Access Compliance Report

Public Rights-of-Way

Intersection ID: 5704	Main Street: E_W_T_HARRIS_BV	Cross Street: N_TRYON_ST	Location: E
ADA ID: C73BDB5720EE	Ramp Type: Perp	Initial Pass/Fail: Pass	Overall Compliance: No
		Severity Score: 15

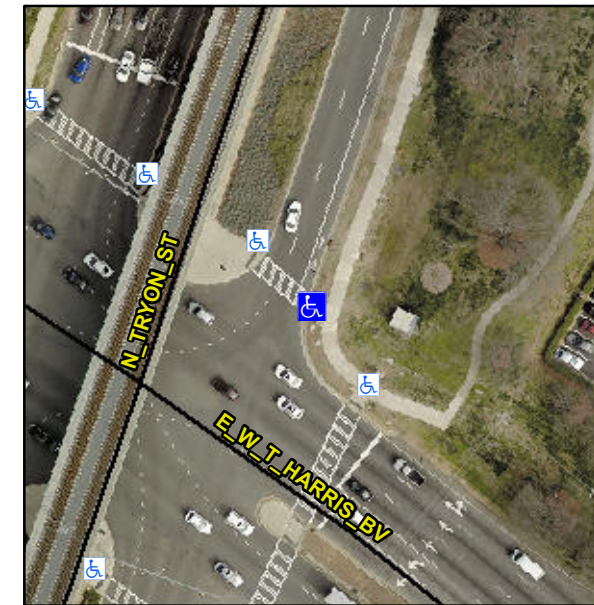
R304.2.2-Perp, R304.3.2-Para, R302.7, R302.7.2

Remove & Replace Landing. Grind Gutter Lip.
